# Bannockburn trotting track proposal

Ref: NOD-390-001

Written Submission on Landscape & Visual matters

October 2024

Photo1 (18mm) - looking south from the Bannockburn Rotunda over site and surronding landscape

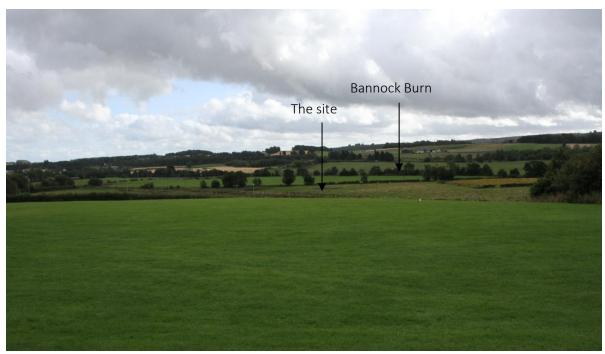
- 5.10 As illustrated in photos 1 and 2 of the Appendix, the proposed development would occupy a very large part of the horizontal view. With a contrast in colour and texture to the surrounding pasture, most of the track and the associated railings would appear very noticeable beyond the immediate foreground. Some of the car parking areas are likely to be visible to the right of view, and in the centre of view, the top of the amenity building is also predicted to be visible. The flag poles would also very noticeable. As such, the proposed development would result in the introduction of uncharacteristic elements and visual pattern. Moreso, it would lead to the creation a of visual focus that competes with, and detracts from, the appreciation of the undeveloped Battlefield landscape. Consequently, the magnitude of change is assessed as medium, resulting in a moderate-major and significant visual effect. During times of operation however, views of activity and parking are likely to result in a major effect.

- 5.19 As demonstrated by the photograph at Viewpoint 1 (see Appendix) the proposed development would affect a relatively large part of the view south from Monument Hill that is currently interpreted as 'View from the Scottish Camp' by information boards immediately south of the Rotunda. Similar views of the site and associated battlefield would be visible from most of Monument Hill. Although most of the proposed infrastructure is low-lying, the introduction of the track and associated railings would appear highly uncharacteristic to its undeveloped and rural locality, and as such, it would change the character of the affected part of the landscape from open and agricultural, to a prevailing sporting amenity and partially developed one.
